**TOWN OF PORTOLA VALLEY
ARCHITECTURAL AND SITE CONTROL COMMISSION (ASCC)
Monday, September 26, 2016
7:00 PM – Regular ASCC Meeting
Special Field Meeting (time and place as listed herein)
Historic Schoolhouse
765 Portola Road, Portola Valley, CA 94028**

MEMORANDUM

RE: Architectural Review for Detached Second Unit,
File # 26-2015, 135 Shawnee Pass, Chang Residence

1. ENTRANCE LANDSCAPE PLAN
 SCALE: 1/8" = 1'-0"
 8973543210

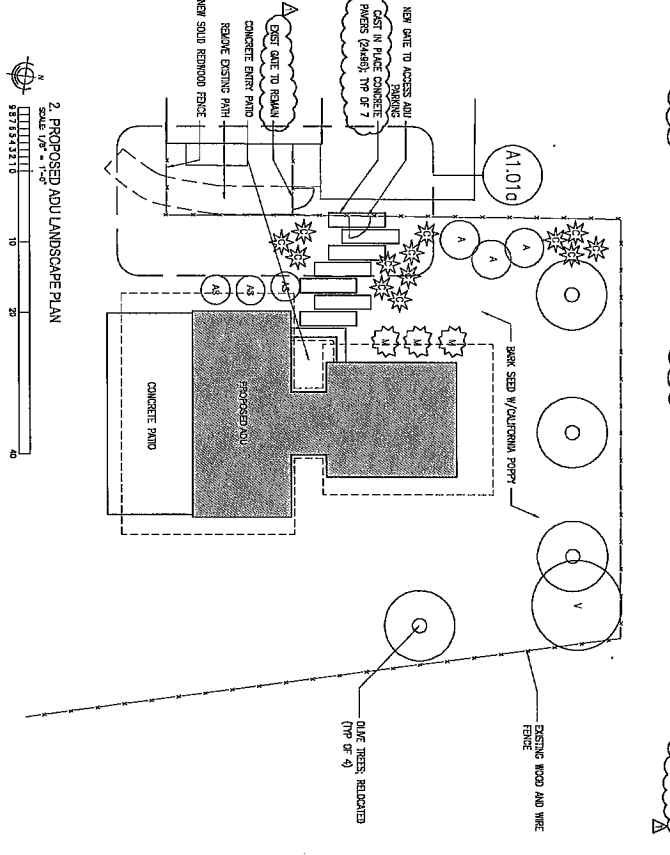
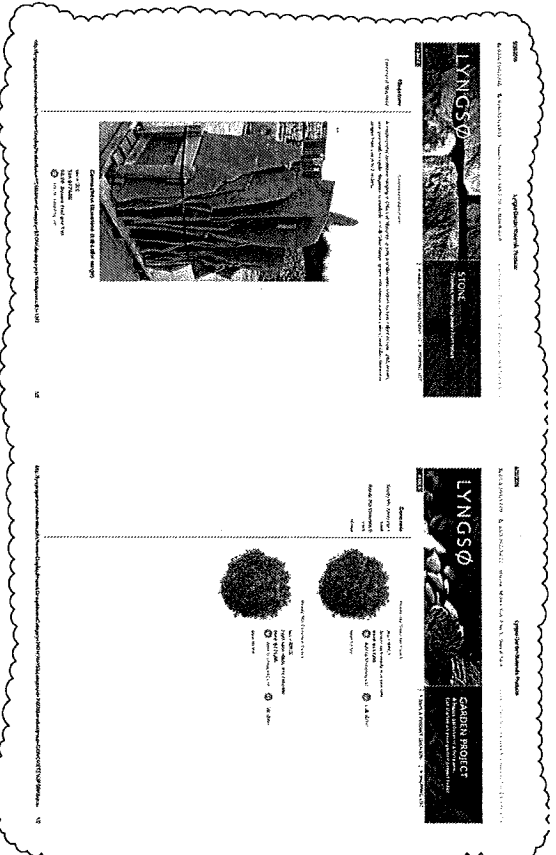
New landscaping is proposed at the front of the existing property, along Shawnee Pass, and at the entrance of the proposed second unit (Landscape/Planting Plan, Sheet A1.01). No

permanent irrigation is planned for either location. At the front, a large portion of the existing loop driveway will be removed, representing 1,348 sq. ft. of impervious surface. An existing path connecting the front area to the side driveway on Shoshone Place (636 sq. ft.) will also be removed. A new pad for two guest parking spaces (455 sq. ft.) will be added to the east side of the remaining driveway.

The front yard will be planted with a range of large and low flowering shrubs, including lavender and ceanothus. Four existing olive trees will be relocated from the second unit building site to the exterior side yard. Additional proposed landscaping for the unit includes manzanita bushes, long grasses, ceanothus, and a bark seed with California poppy along the street-facing yard. Other than the four relocated olives, only one young magnolia grandiflora tree will be removed, for the new guest parking spaces. A detailed planting plan for the front yard and second unit lists species type and location (Landscape/Planting Plan, Sheet A1.01).

A flagstone walk is proposed to replace the removed driveway section, and would connect the front door to Shawnee Pass. A flagstone of Connecticut Bluestone is proposed. In addition, the plans include an optional use of the stone along the shallow patio along the front of the house, and covering an optional low concrete wall at the end of the remaining front drive.

FENCE DETAIL PLAN
SCALE: 1/4" = 1'-0"

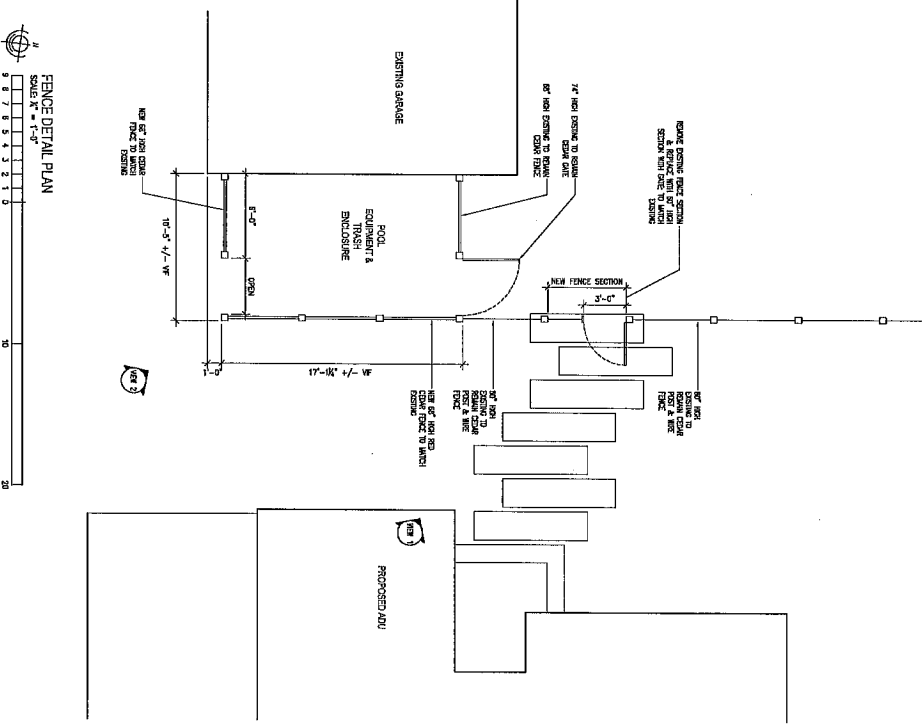
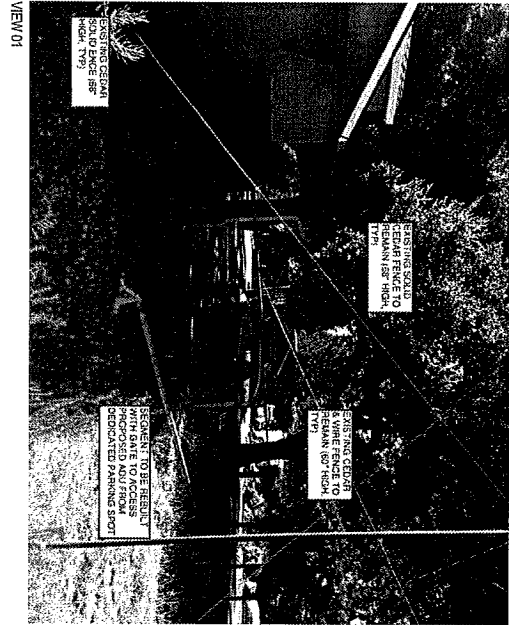
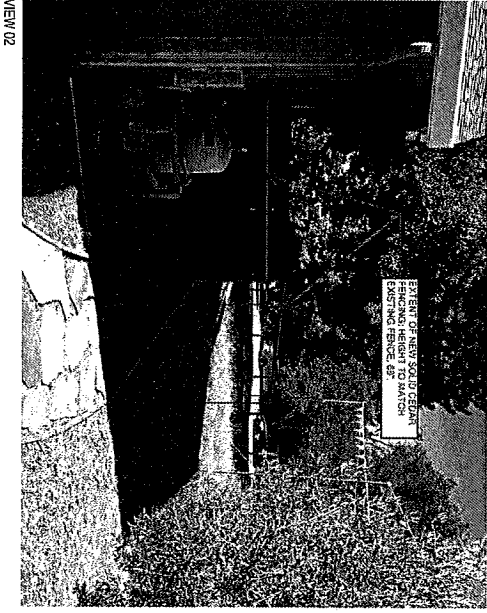
Two types of fencing are shown near the new second unit (Fence Details, Sheet A1.01a). One is a continuation of the existing 68" cedar fence with rounded 74" gate. The existing fencing screens the north side of pool equipment and trash enclosure area from street view, and the proposed fence will enclose this area within 68" cedar fencing to match. Both existing and proposed cedar fencing are well behind the setback line and therefore conforming.

The second fencing type is existing cedar post and wire fence which already surrounds the area of the proposed second unit and landscaping. At 60" (5 feet), this fence is non-conforming both for its height and location. Code section 18.43.030.B.1 states that "Fence heights shall not exceed four feet in front yards, six feet in side and rear yards, and four feet in side yards along road rights-of-way." The fence location (Sheet A1.00) is slightly beyond the property line, putting it in the public right of way. For these reasons, staff recommends a Condition of Approval (Condition 3) requiring the modification of the existing cedar and wire fence to a conforming height and location.

SITE PLAN - SCALE 1/8" = 1'-0"

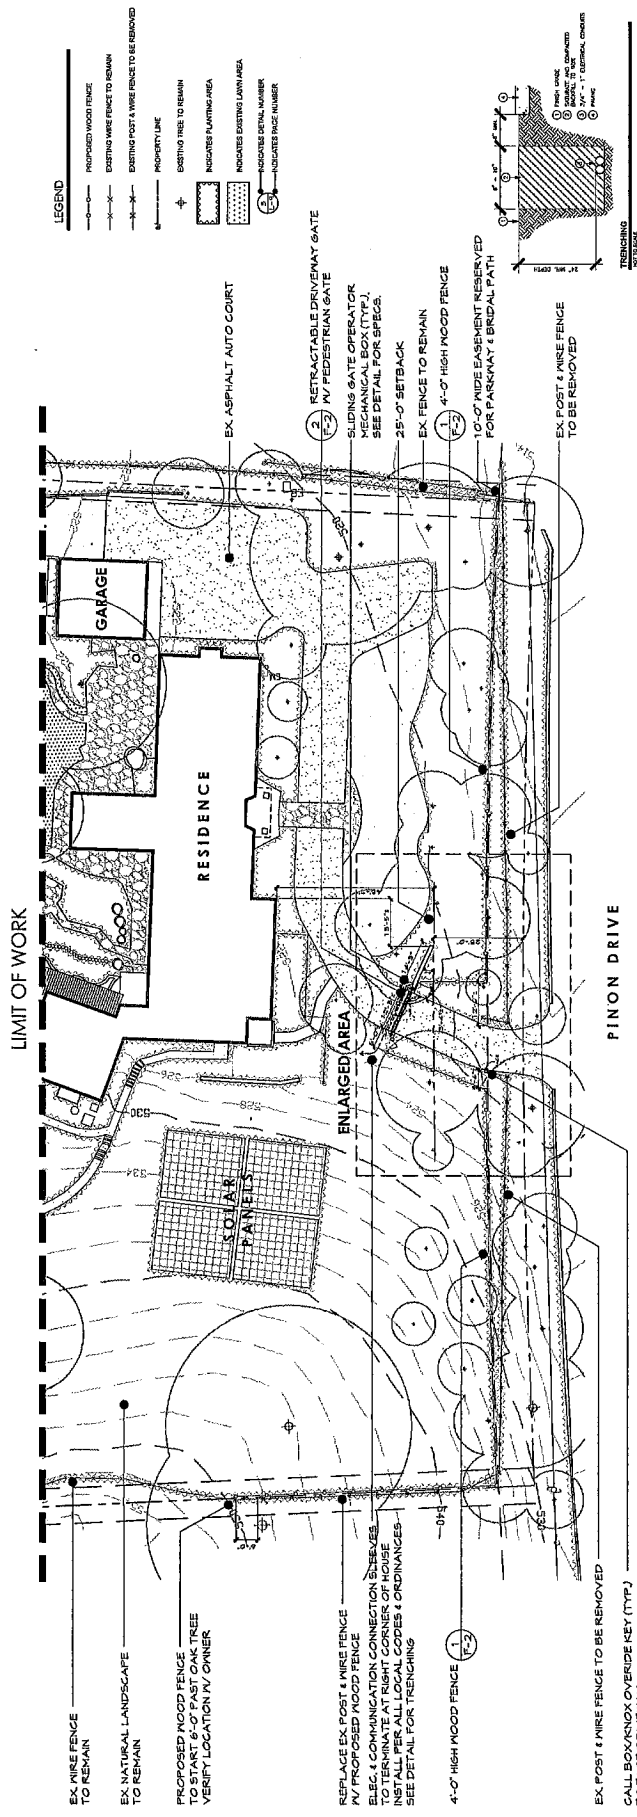
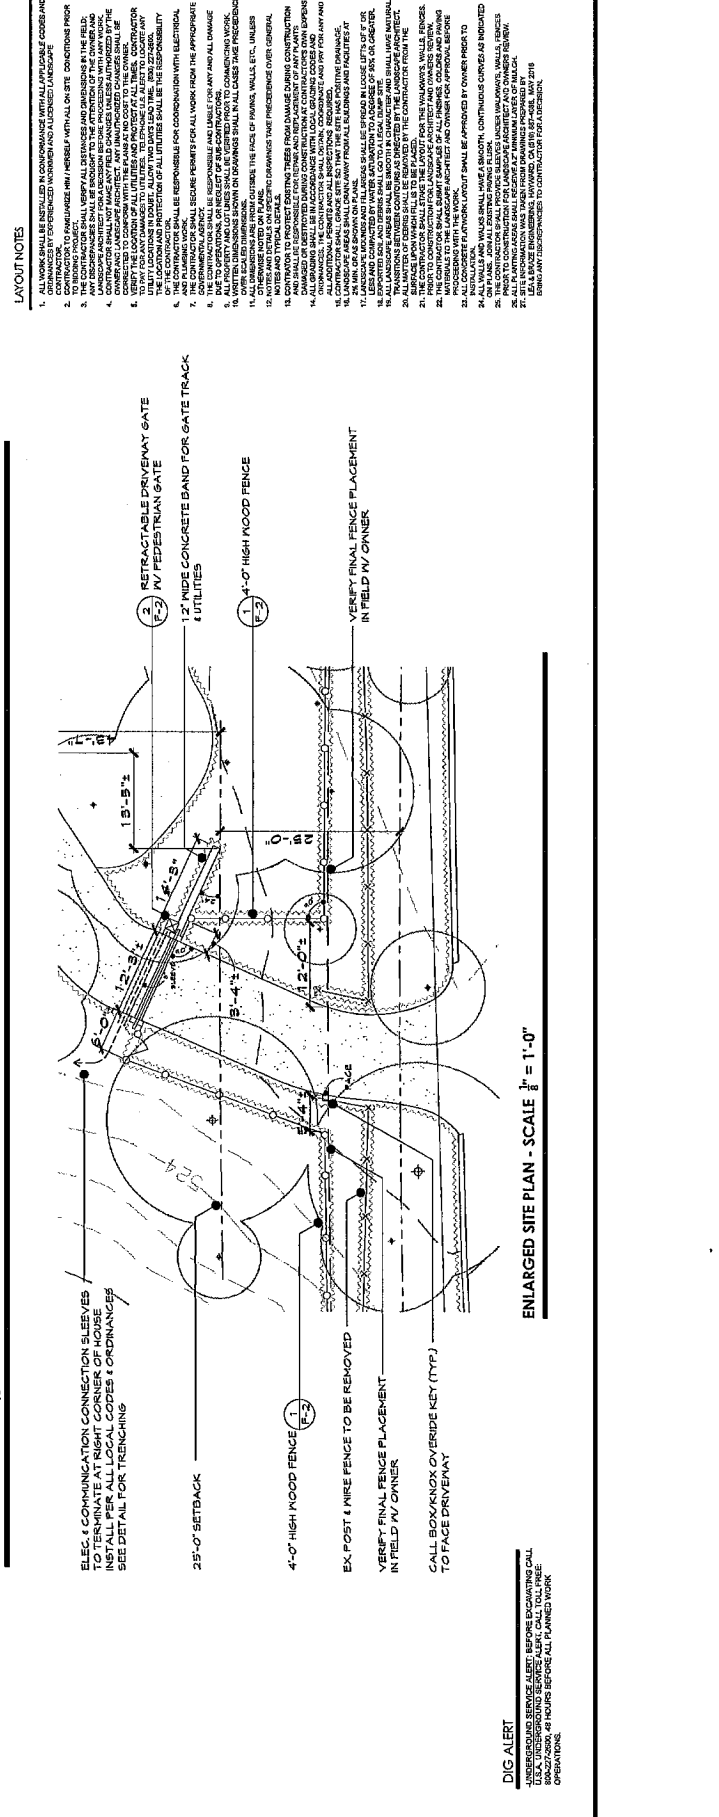
The entry gate will be connected to a new 4' tall horse fence to replace existing non-conforming post and wire fencing that encroaches upon the parkway and bridle path easement running along the front of the property. The new fence will be constructed of 2"x6" redwood rails and 6"x6" redwood posts. A new section of horse fencing will also be installed along the north side of the property extending approximately 66' back from the front property line to be tied into existing wire fencing. The existing wire fencing on the southern side of the property will remain.

The property is located within an R-E/2.5 zoning district. In this district, a driveway entry gate must be placed away from the property line at least one-half the distance of the required 50-foot front yard setback (PVMC Section 18.42.016.A). As shown on the site plan, the entry gate is proposed to be located 25 feet in from the front property line. The opacity limit for gates within the front yard is 50% (PVMC Section 18.43.040.A.2). An area calculation of the gate is provided in Attachment 5 that demonstrates compliance with the opacity limit. Both the gate and fencing have a maximum height of four feet, meeting the ordinance height limit (PVMC Section 18.43.030.B.1). The entry gate and fencing do not exceed the color reflectivity value of 40% as required under PVMC Section 18.43.050.A.

In addition to the gate, the applicant is proposing a horse fence that will attach to the entry gate and extend along the side property lines as shown on Sheet 1. The fencing along the western side of the property will be installed inside the property line and follow a path that will not impact the existing trees and vegetation. The fencing along the eastern property line will follow the property line up to the top of the driveway.

1. No other modifications to the approved plans are allowed except as otherwise first reviewed and approved by the Planning Director or the ASCC, depending on the scope of the changes.
2. The entry gate rails, fence posts, and rails shall be constructed of unstained redwood per the approved project plans. Any change to the proposed materials must be approved by the Planning Director prior to construction.
